Location of Construction: 243 Congress St Portland, ME 04101		Owner: [blank]		Phone: [blank]	
Owner Address: [blank]		Leasee/Buyer's Name: [blank]		Phone: [blank]	
Contractor Name: [blank]		Address: 400 ...		Phone: [blank]	
Past Use: [blank]		Proposed Use: [blank]		<b>COST OF WORK:</b> \$ 24,000.00 <b>PERMIT FEE:</b> \$ 100.00	
		<b>FIRE DEPT.</b> <input type="checkbox"/> Approved <input type="checkbox"/> Denied		<b>INSPECTION:</b> Use Group: [blank] Type: [blank]	
Proposed Project Description: [blank]		<b>PEDESTRIAN ACTIVITIES DISTRICT (P.U.D.)</b> Action: <input type="checkbox"/> Approved <input type="checkbox"/> Approved with Conditions <input type="checkbox"/> Denied		Signature: [blank] Date: [blank]

Applicant: Amy Mulkerin  
Address: 243 RAY ST  
Assessors No.: 406-F-048

LAND USE - ZONING REPORT

BUILDING PERMIT REPORT

Amended Plan  
29 S Ray St. Portland.

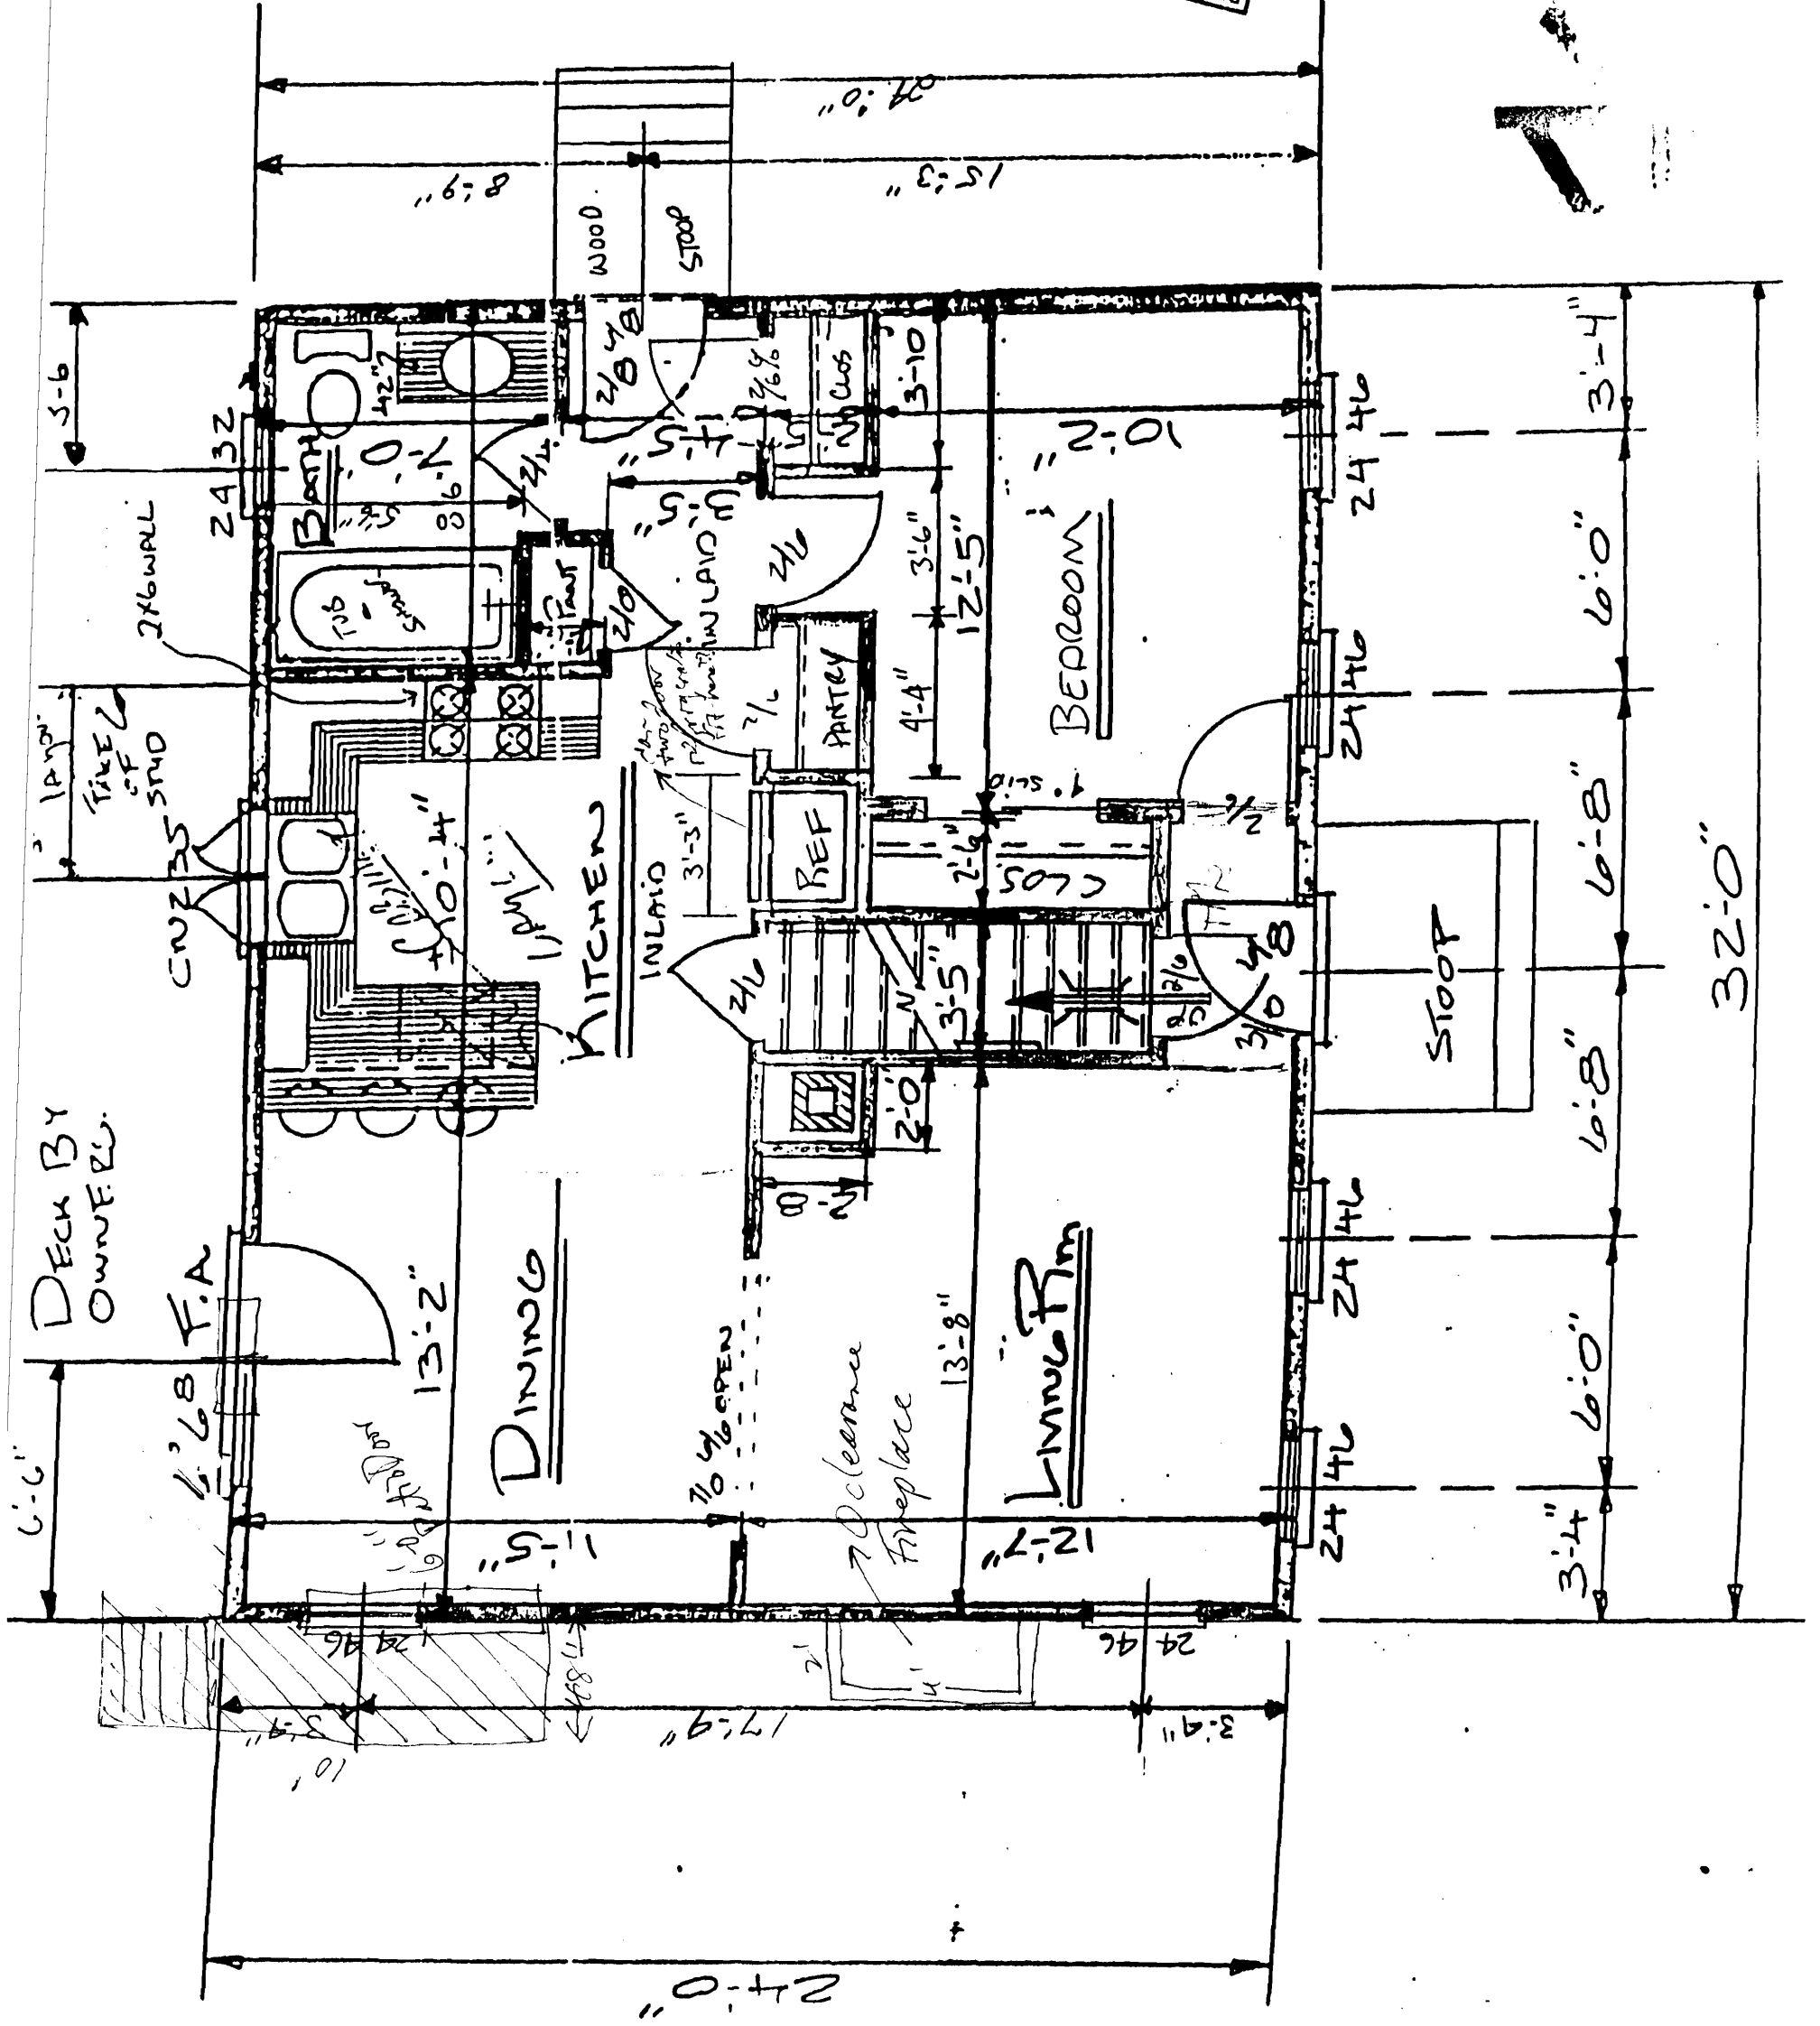
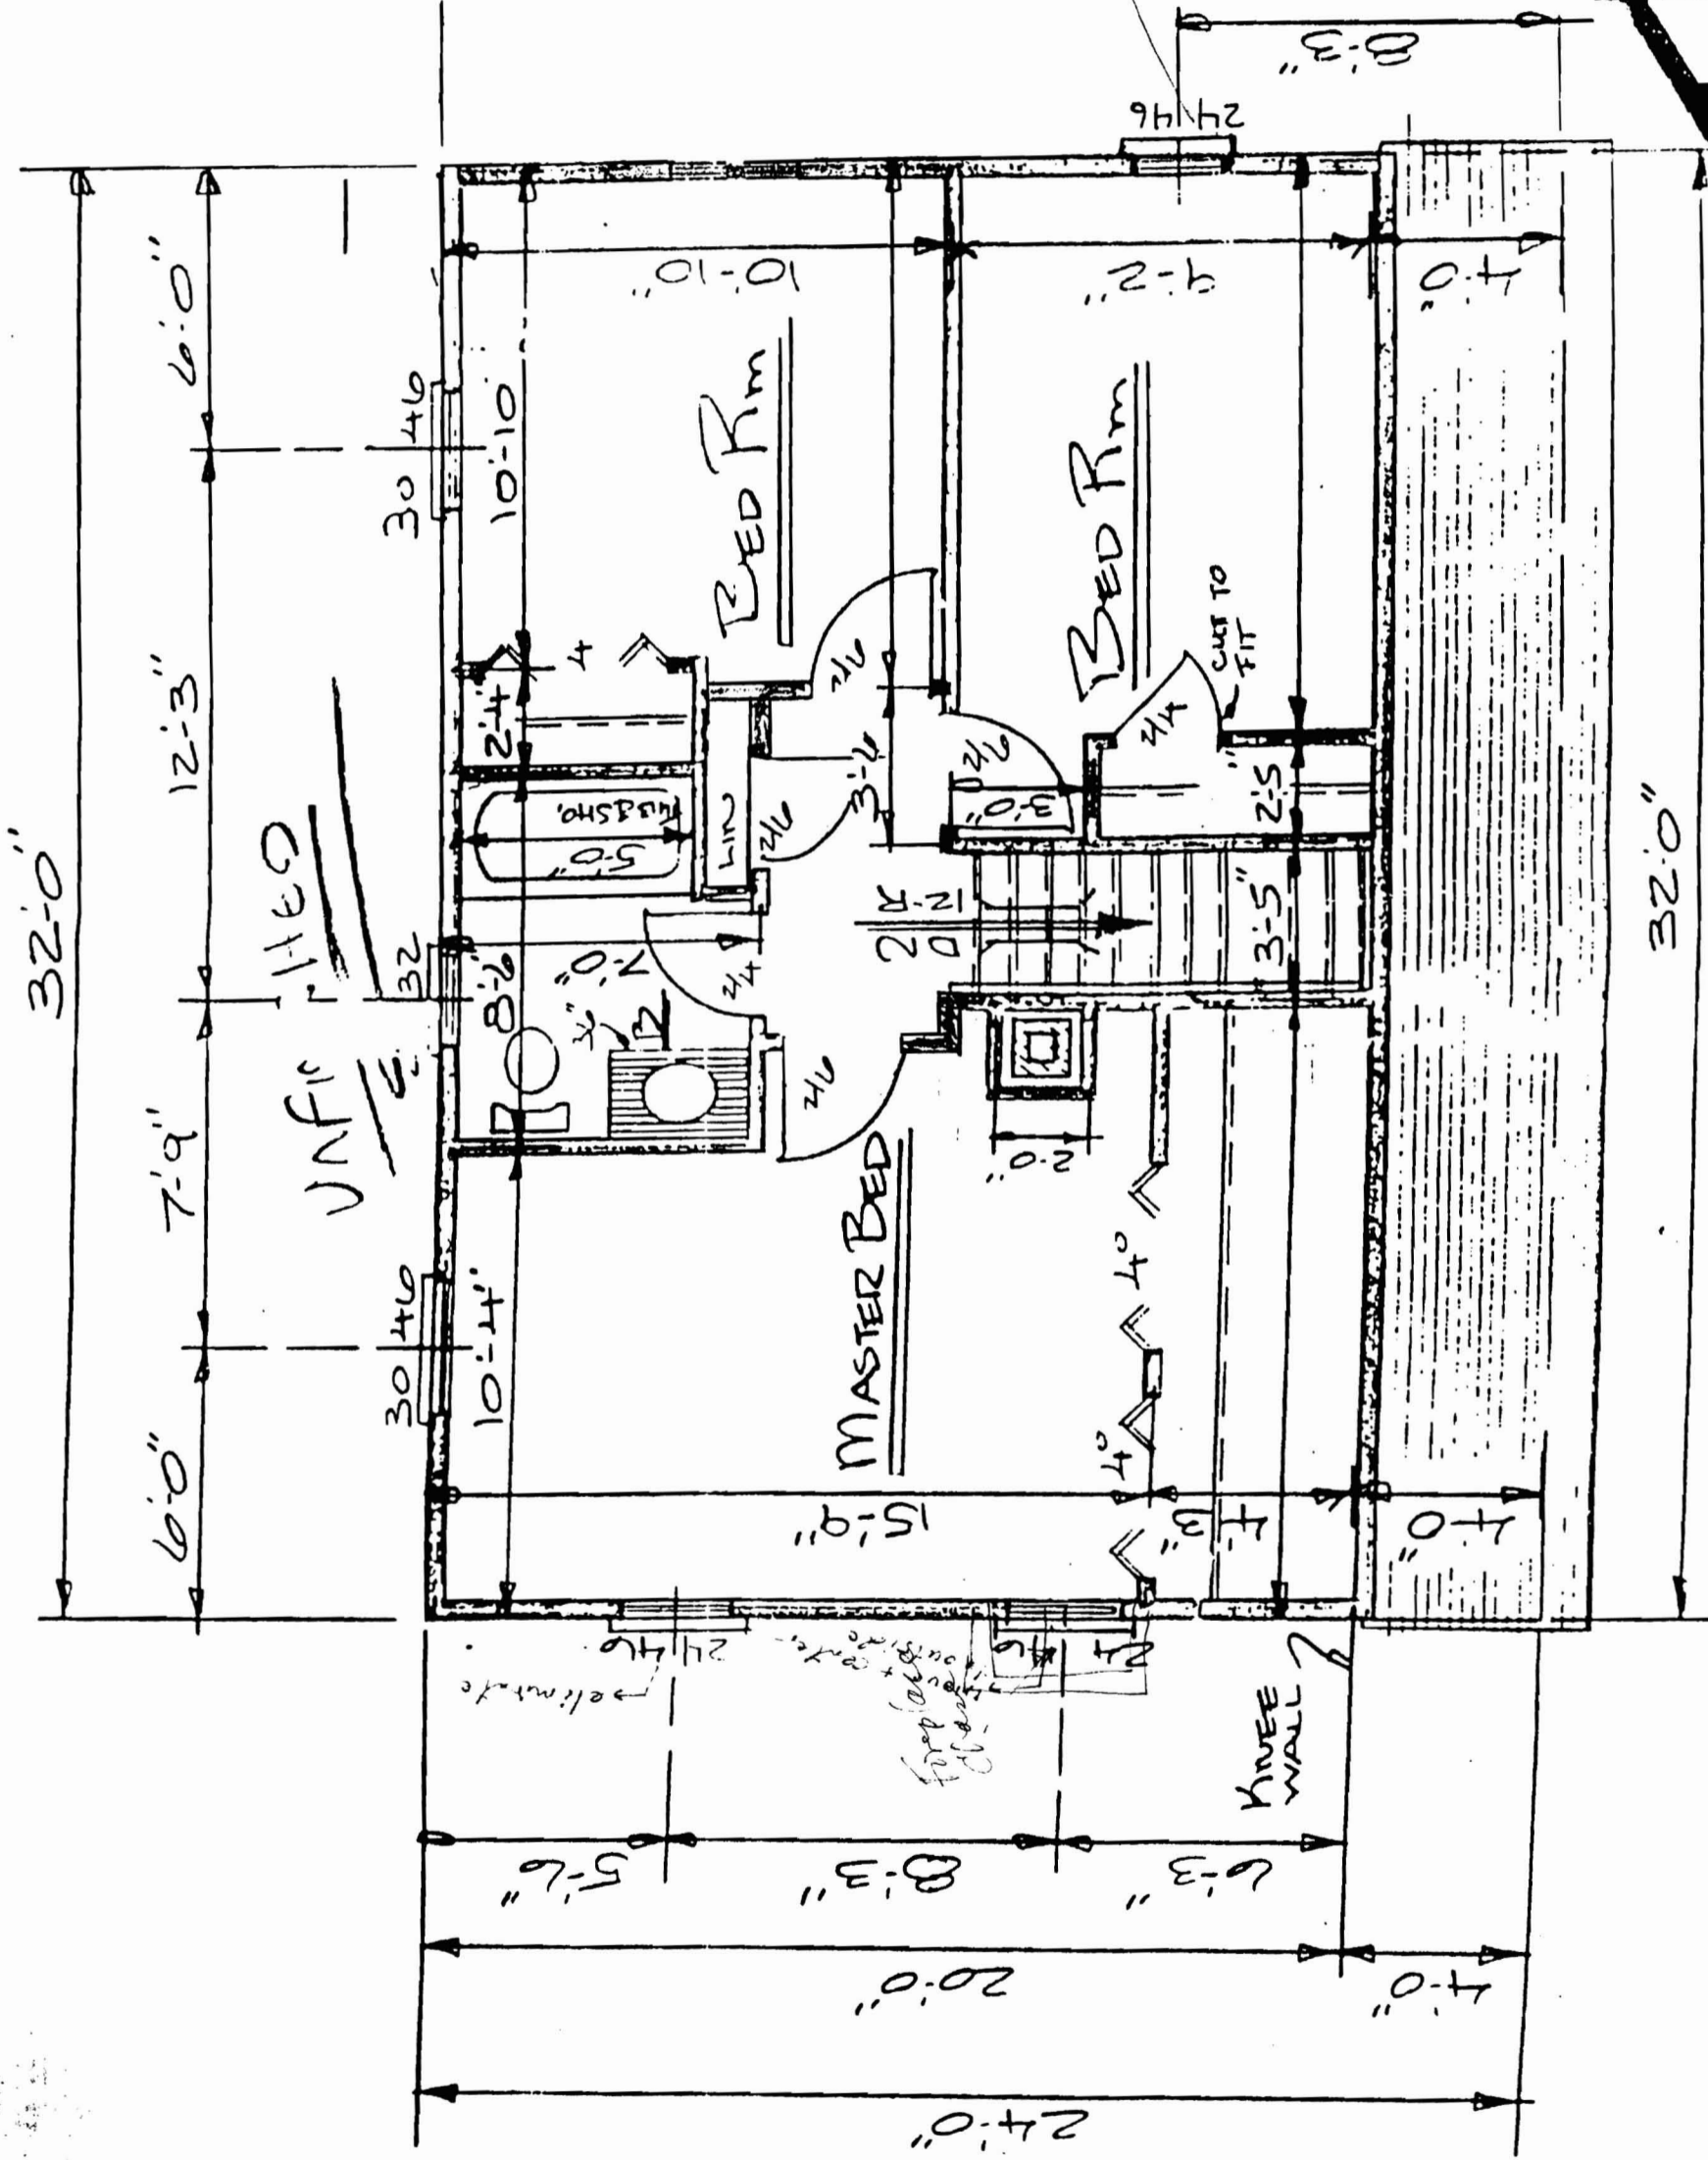
~~31.~~ Your submitted application and plan did not show any information  
on the fireplace or chimney. This information must be submitted  
and approved before work begins on these items.

This Plan was  
constructed in  
REVERSE
